SAN MATEO-FOSTER CITY SCHOOL DISTRICT FACILITIES AND CONSTRUCTION ADDENDUM NO.2

Date: May 6, 2026

**Project: FIESTA GARDENS/TURNBULL CHILD DEVELOPMENT CENTER FIRE ALARM
UPGRADE**

Bid No.: 26-07

FA3.1

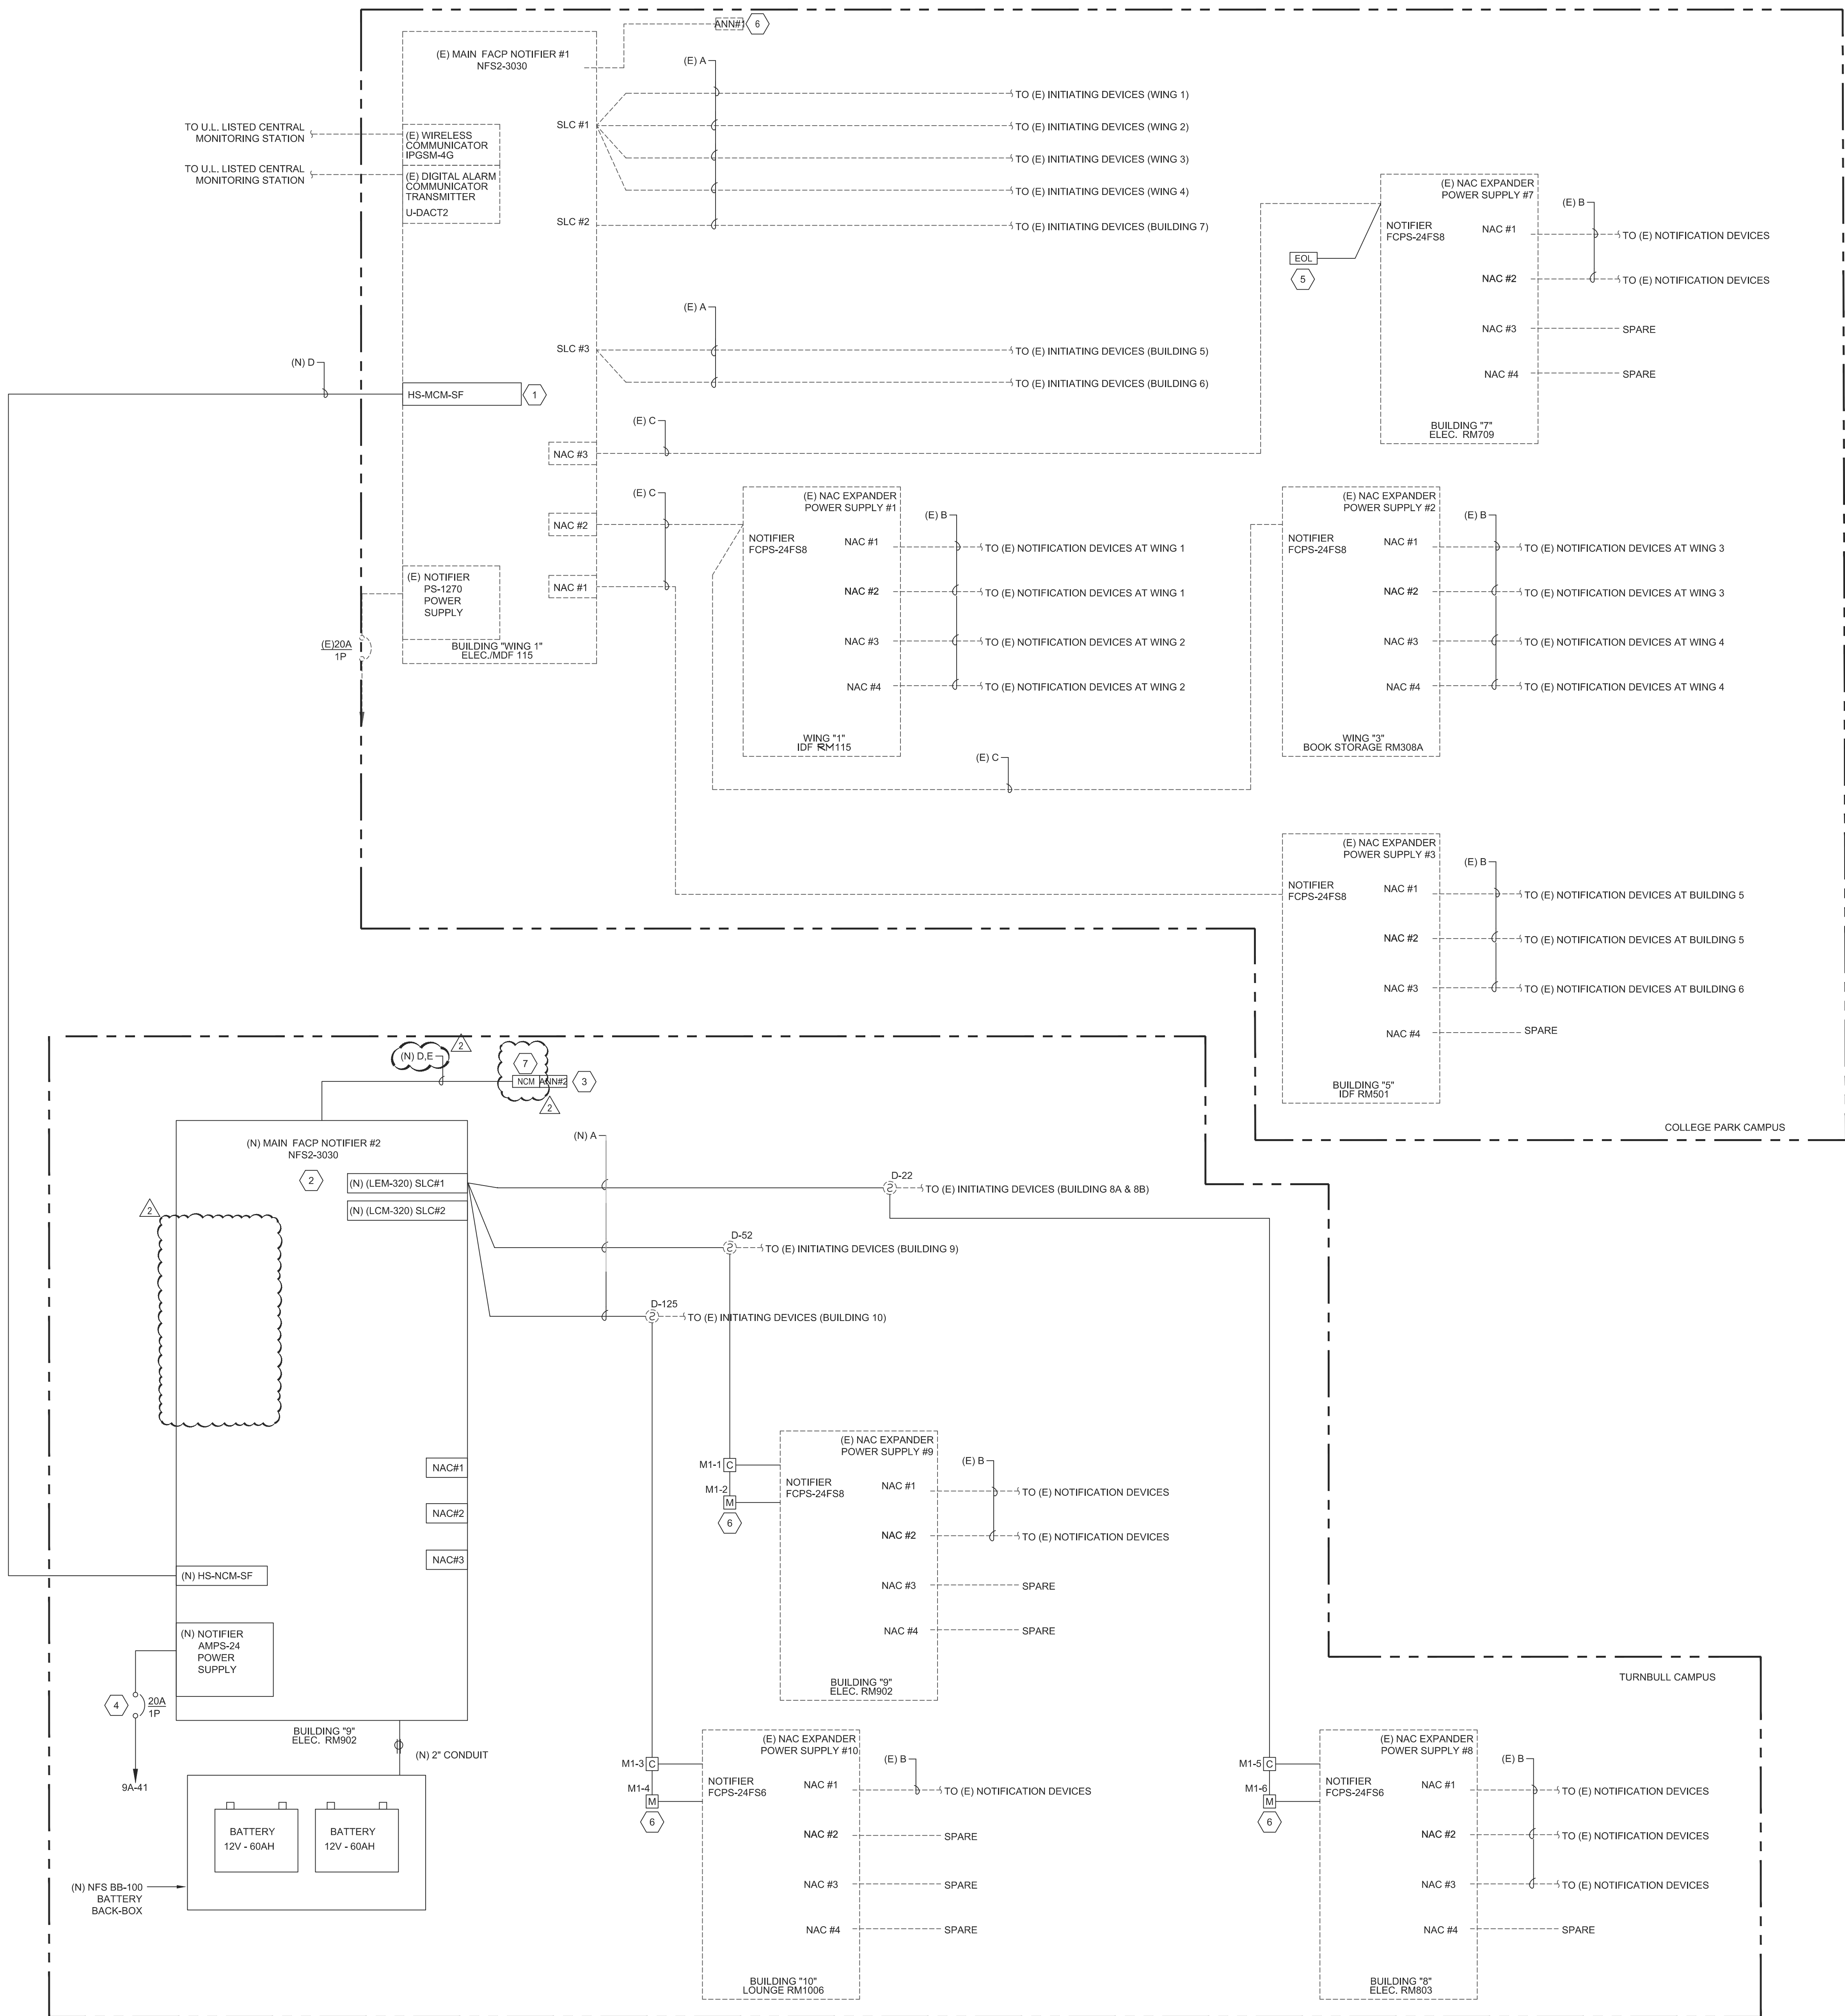
Reference: Drawing FA3.1 NEW FIRE ALARM RISER DIAGRAM

1. Revised cable tage for new annunciator #2.
2. Added sheet note No. 7.
3. Added fiber network communication module for new annunciator.
4. Removed equipment from new FACP from the riser.

- PROVIDE NCM FIBER OPTIC COMMUNICATION MODULE FOR NEW NCA-2 CONTROL ANNUNCIATOR AS REQUIRED.
